# FNC Position

- **A basic scheme of maintaining associations of Remote (Client) MAC addresses and RPR MAC addresses**
  - Client VID optionally learned
  - 802.1D/Q Like learning/ageing mechanism
  - No GVRP, GARP etc. participation in the SAS
  - Management I/f to retrieve/define MAC address associations
- **Proposed extensions to address**
  - Incomplete learning/persistent flooding issues
  - Switching between Directed/Undirected modes and its impact on Strict mode frames
- **Clarification that SAS <=> SAS Only is not a technical limitation? Are there possible extensions?**
- **Clarification of environments where SAS is used.**

# Incomplete Learning Issue

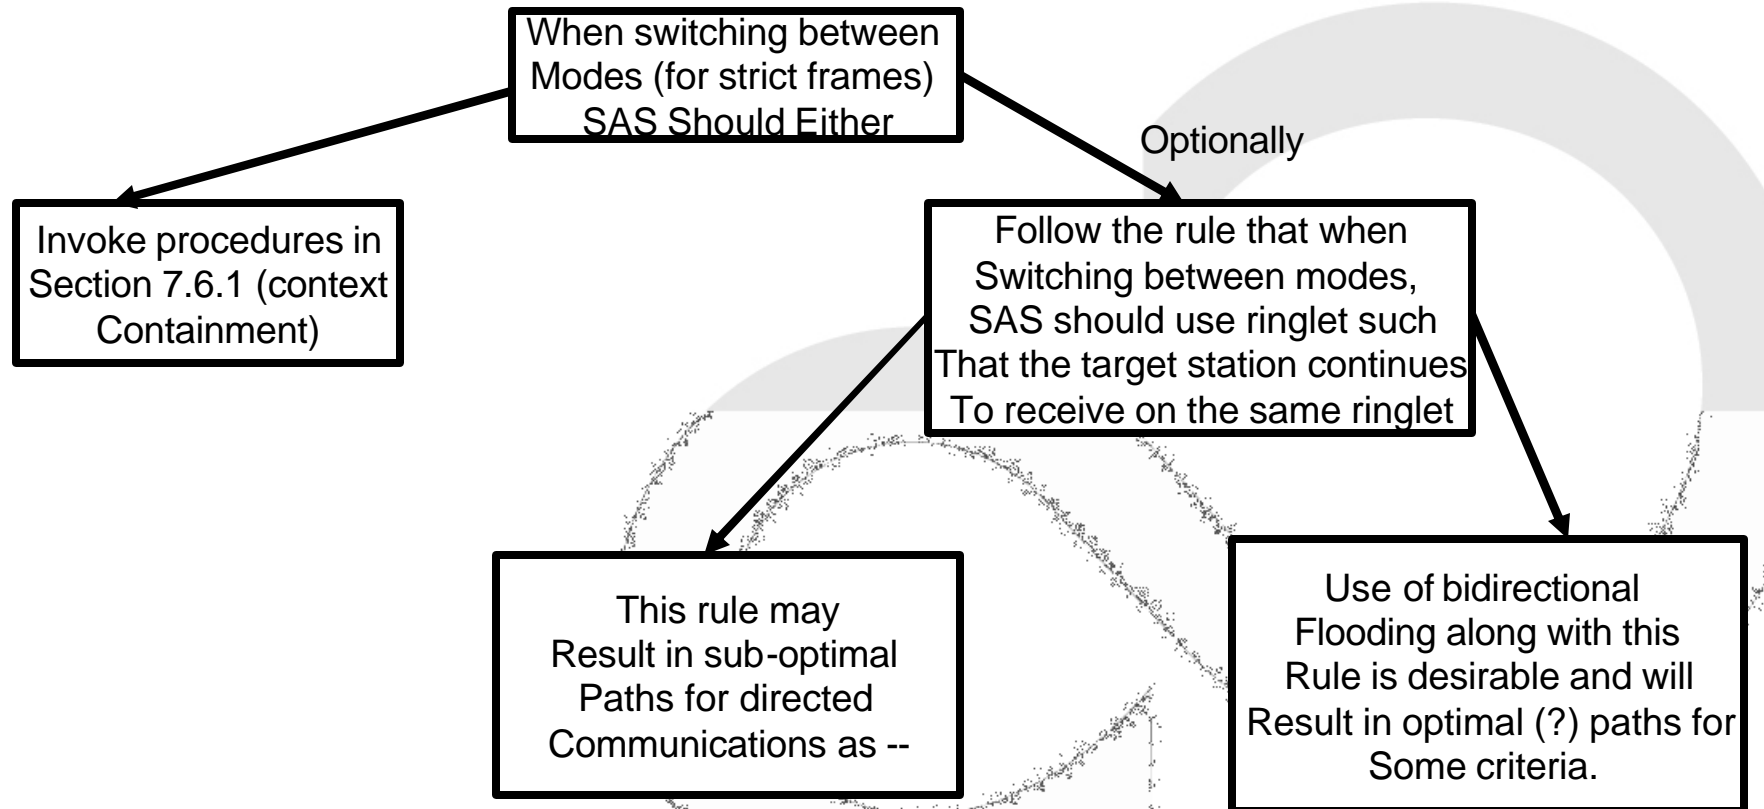
## ■ Can the basic scheme be supplemented by a simple extension to alleviate the incomplete learning issue?

- Timer based scheme – Maintain a flag with each LAN side entry in the FDB
- The flag is set by a timer (once every  $n$  seconds,  $n$  should be less than minimum ageing time for all SAS aware stations in the ring) and also set automatically when a new FDB entry is created
- When sending packet, if the flag is set -- use undirected transmission and then reset the flag
- If a packet is flooded on to the ring for other reasons, then reset the flag for that Client address
